DESCRIPTIVE REPORT

Registry No. H11836

Descriptive Report to Accompany Hydrographic Survey H11836
Project OPR-J977-DE-08
Gulf of Mexico, Louisiana
Blind Bay
Scale 1:10,000
June 2008 – January 2009
David Evans and Associates, Inc.
Lead Hydrographers: Jonathan L. Dasler, Jason C. Creech

Figure 4. New Shoal

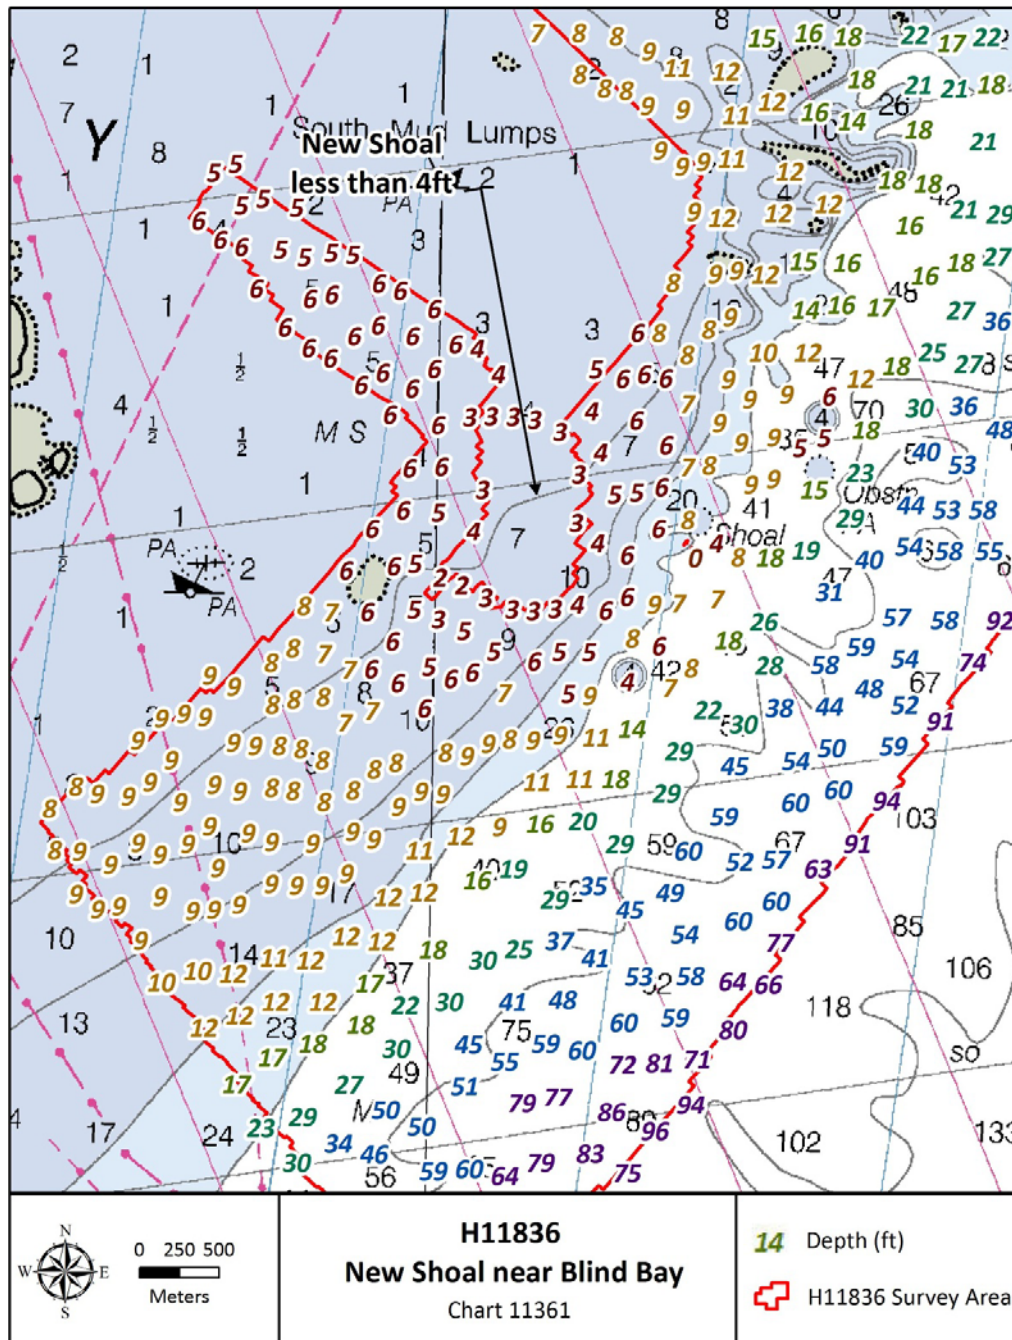
- H11836 located a new mound like shoal east of Blind Bay. Figure 4 depicts the migration of the shoal less than 4-feet in this area, which extends seaward of the charted 10-foot sounding. The hydrographer recommends charting the area based on current hydrography. **Concur. Area includes intertidal zone, sent as DtoN during AHB processing (see DR Appendix I).**

Figure 8. AWOIS item 14133 submerged pipe

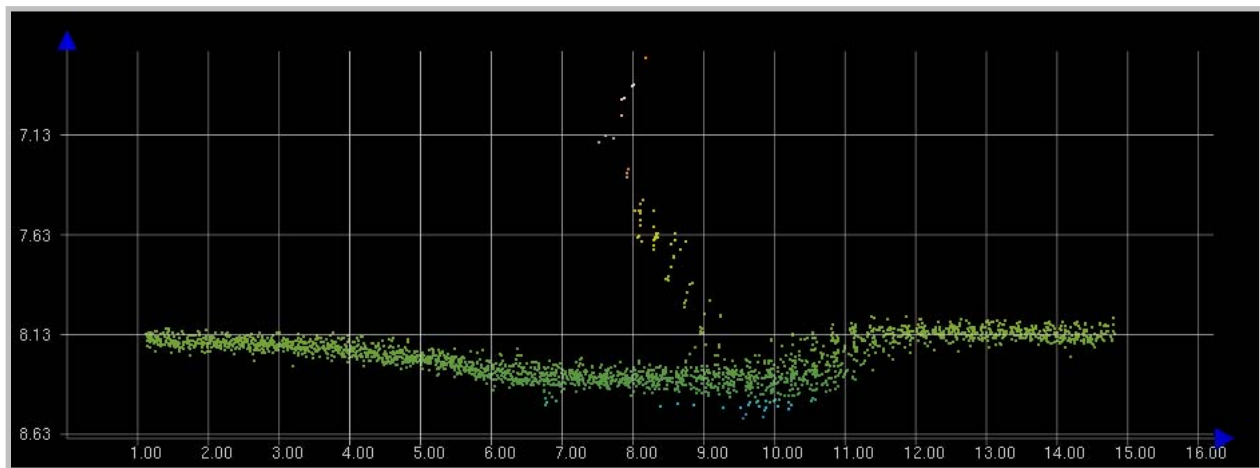
- The charted submerged pipe (uncovers) (AWOIS 14133) was located at 29-13-14.022N, 088-59-50.907W (Figure 8) 420 meters west of the charted position **29-13-11.629N, 088-59-35.513W** near a disproved charted platform. The pipe rises 5.0 feet (1.5 meters) and has a least depth of 22.1 feet (6.7 meters). The search radius for AWOIS 14134; submerged rig, (charted Obstruction PA) significantly overlaps the search radius for AWOIS 14133, however there is no indication of the rig framing in sonar imagery as discussed in the AWOIS. The hydrographer therefore believes this to be the charted submerged pipe and recommends removing the pipe and uncovers annotation and charting a submerged pipe as depicted in the S-57 feature file. **Concur with clarification Chart dangerous obstruction "Subm Pipe" least depth 22 feet at the survey position.**

Figure 10. New obstruction

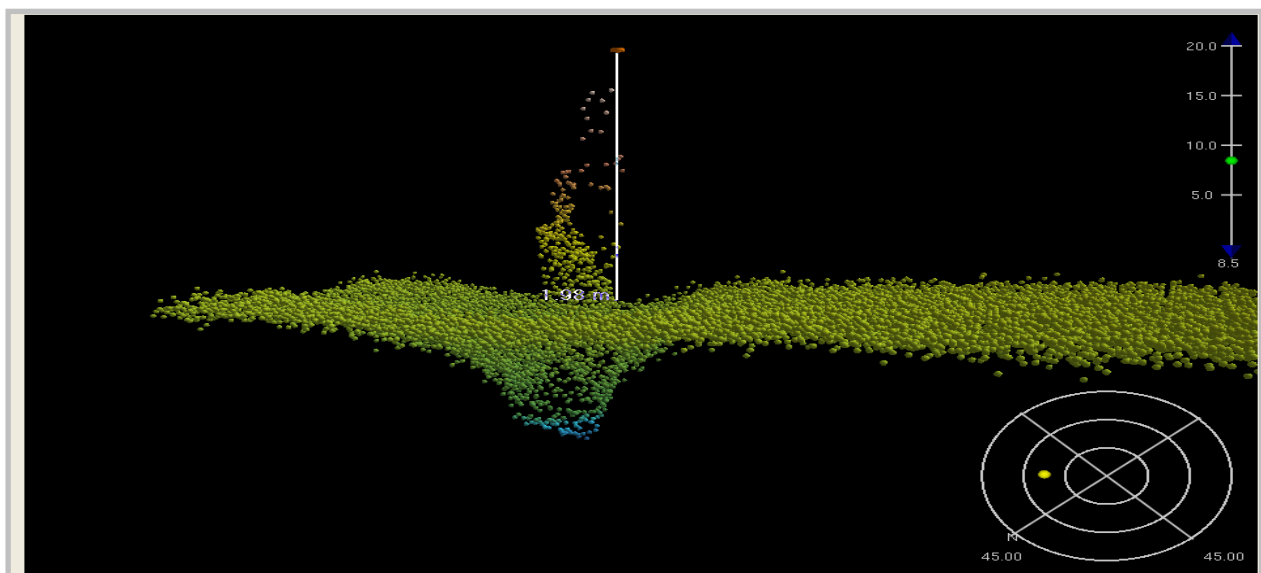
An obstruction was located at 29-14-26.145N, 89-02-43.445W (Figure 10). The obstruction rises approximately 6.6 feet (2.0 meters) from the natural seafloor and has a multibeam least depth of 16.86 feet (5.1 meters). The obstruction is included in the S-57 feature file. **Concur with**

clarification. Office processing determined that the feature is insignificant in relation to charted features and bathymetry in the vicinity. Chart as 17 foot sounding at the survey position.

Figure 11. New wreck

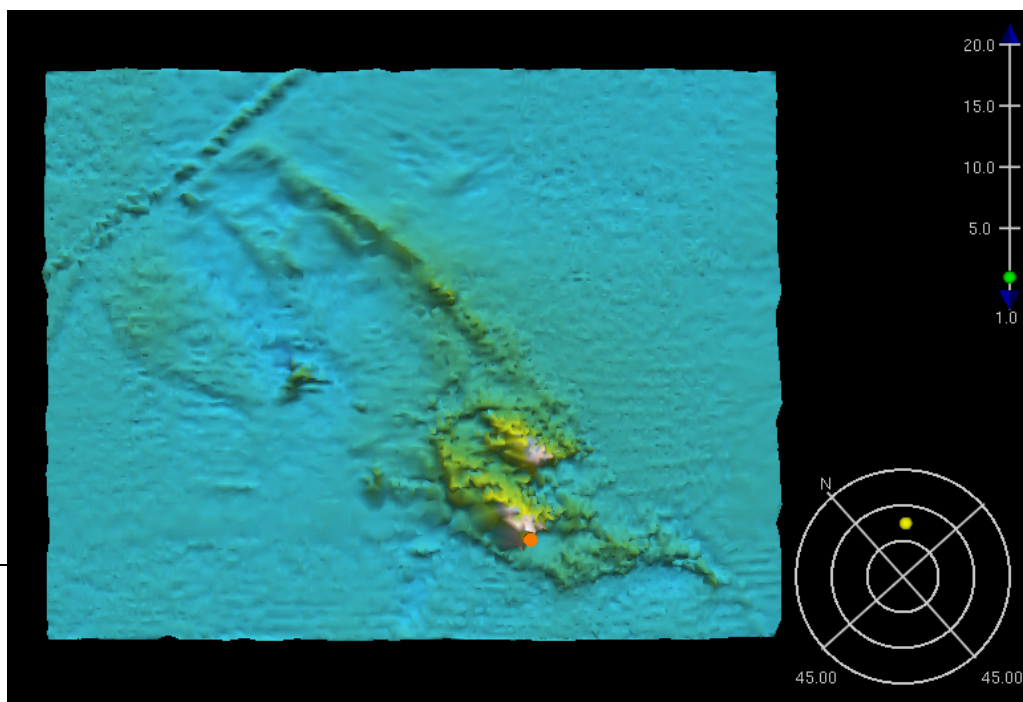
The least depth of the wreck is 13.19 feet (4.0 meters). The wreck is included in the S-57 feature file. **Concur with clarification.** Chart dangerous wreck least depth 13 feet at the survey position.

Figure 13. H11836 Mischarted Platforms

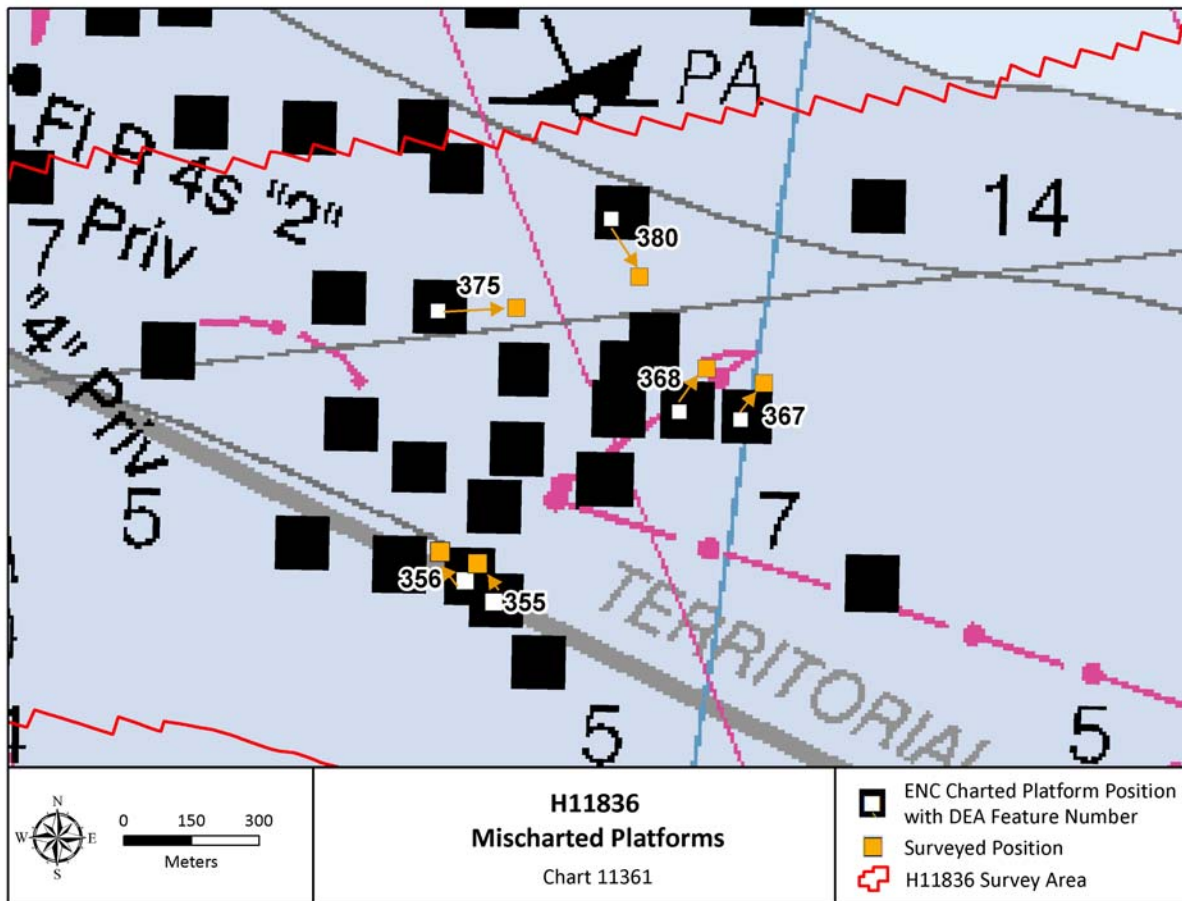
Six (6) platforms were found to be mischarted (Figure 13) and are detailed in tabular format in Appendix II *Survey Feature Report*. The hydrographer recommends charting these features as depicted in the S-57 feature file. **Concur with clarification. Recommend to update the position of all charted platforms per present survey findings.**

Figure 1 AWOIS 14133 submerged pipe

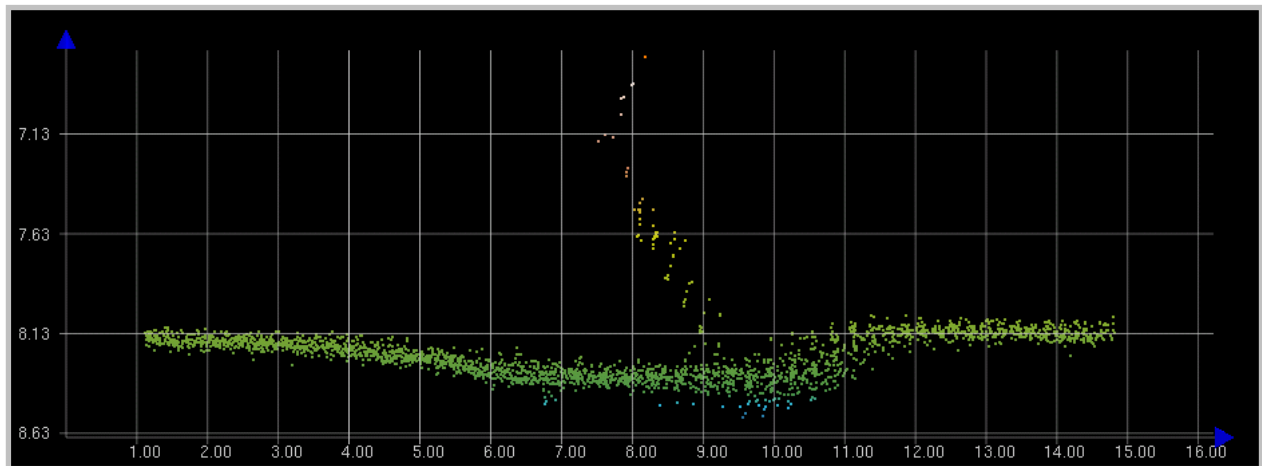
The hydrographer recommends removing the pipe and uncovers annotation and charting a submerged pipe at the surveyed position.

Concur with clarification. Chart dangerous obstruction "Subm Pipe", least depth 22 feet at the survey position.

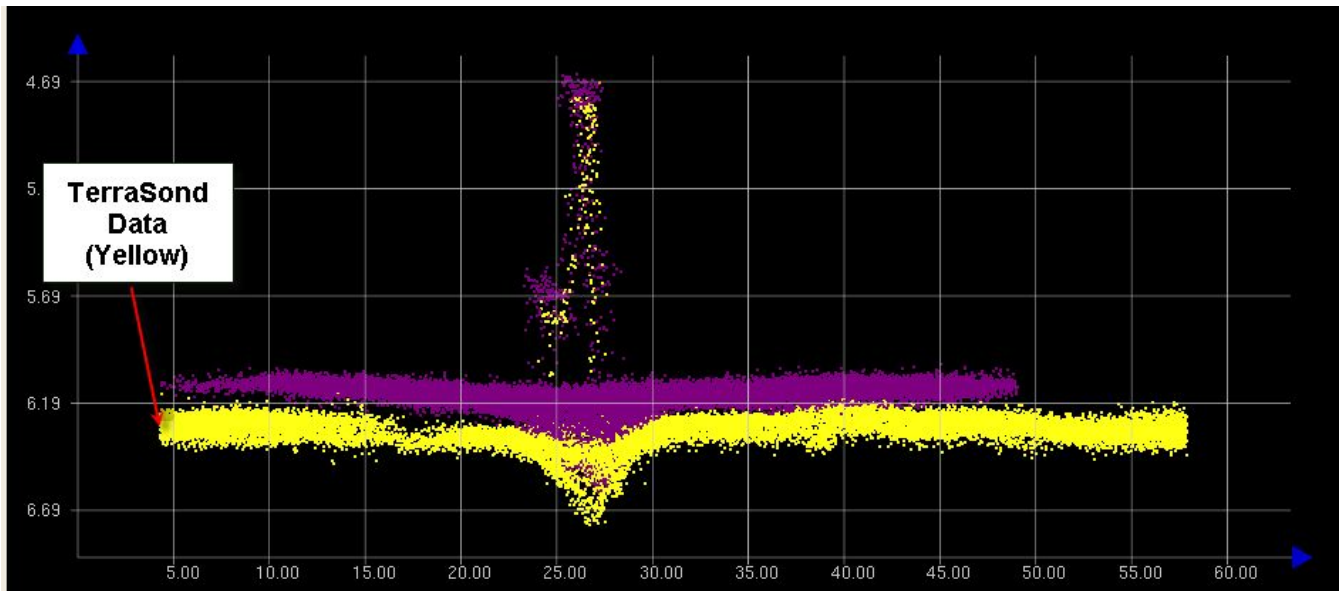
Thank you for your quick reply. I am trying to determine if a ~20cm offset that I am seeing between our two datasets is a result of tides or an error in the HVF. As a way of background, Terra acquired data over a wreck and an obstruction. DEA acquired singlebeam and multibeam from two different vessels on the obstruction so this area works as a small reference surface (see screen capture below). Terra has submitted an additional HVF that includes a new latency value, which resolved an observed horizontal offset. The new HVF also includes TPE values.

First, I am curious if the draft value in the HVF is in respect to the phase center of the 8101? If not, that could account for an approximately 12cm vertical offset (I think- this number is from the top of my head it might be more). Along those lines can you please send me a bar or leadline check done after the head was tilted. This would make it easier to justify the offset as tidal in the DR.

Second, I was reviewing the supporting files Terra submitted to DEA on 06 March and I have a couple of questions regarding the TPE values in the HVF. In the Seapath Configuration Report the From CG to antenna #1: is listed as X: 1.804 Y: -1.417 Z: -5.372 [m]. In the Bella Marie Sketch the X and Y values are transposed and there is a slightly different Z value. I know nothing about the Seapath coordinate system and there is a heading offset listed as -90 degree which might explain the discrepancy between the X and Y coordinate systems. Can you confirm this? Also, the sketch shows the primary GPS1 antenna (PRIM) starboard of the RP, but lists a negative value (CARIS convention). Is this a typo?

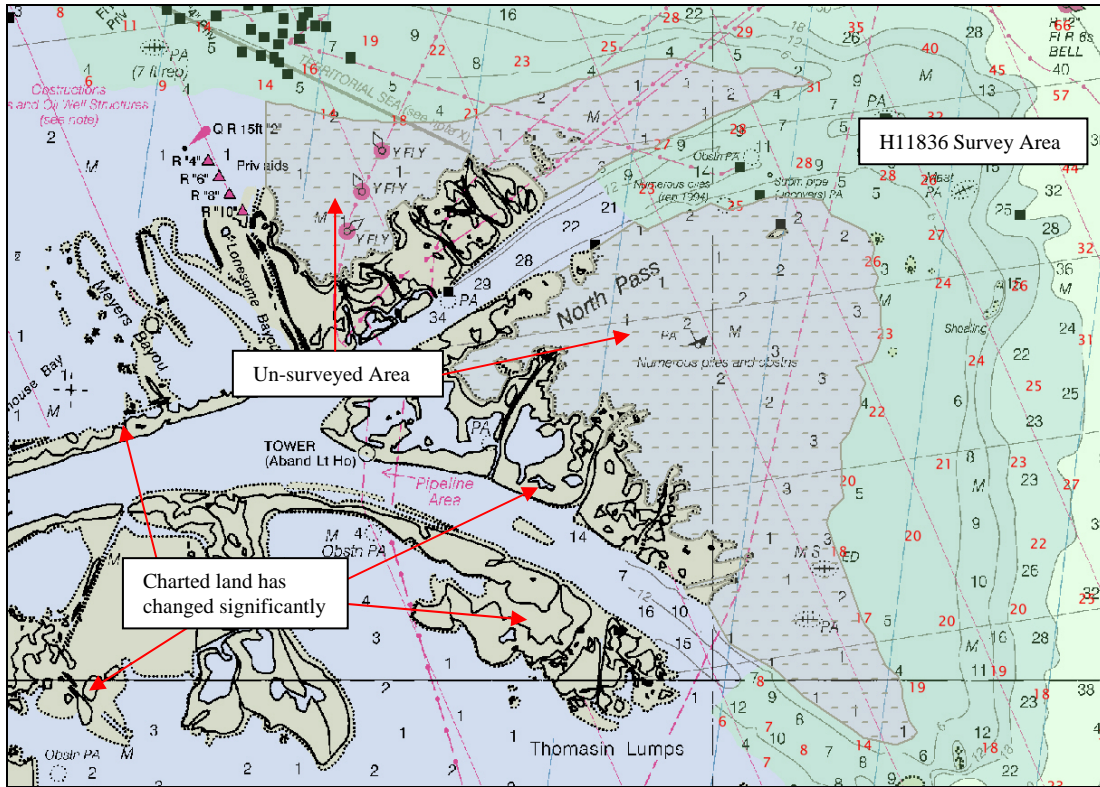
Twenty-three (23) bottom samples were obtained on Day Numbers 202, 206 and 207 (July 20, 24 and 25, 2008) and are included in the S-57 attributed feature file in the *Supporting Data* folder. A table listing the position and description of each bottom sample is included in Appendix V *Supplemental Survey Records and Correspondence*, along with photographs of each sample. **Concur.**

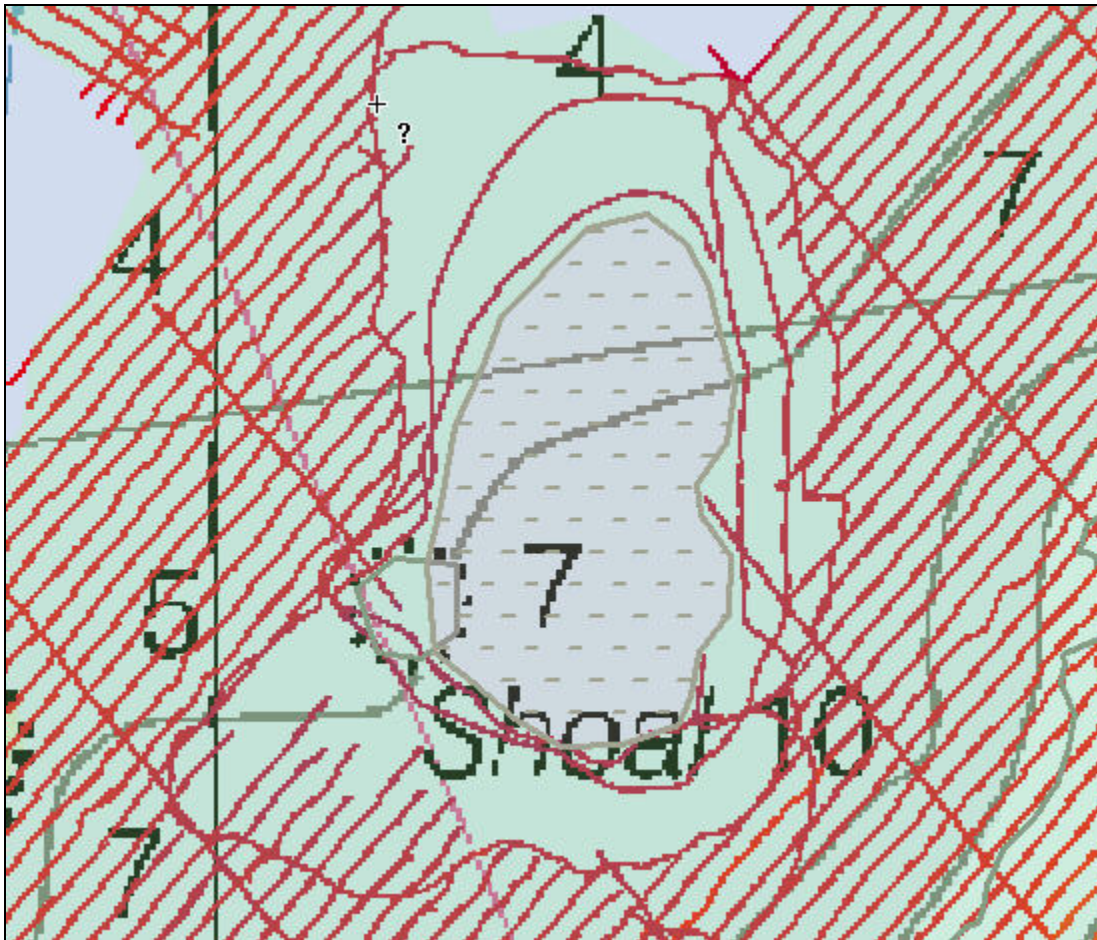
LETTER OF APPROVAL

OPR-J977-DE-08
REGISTRY NO. H11835
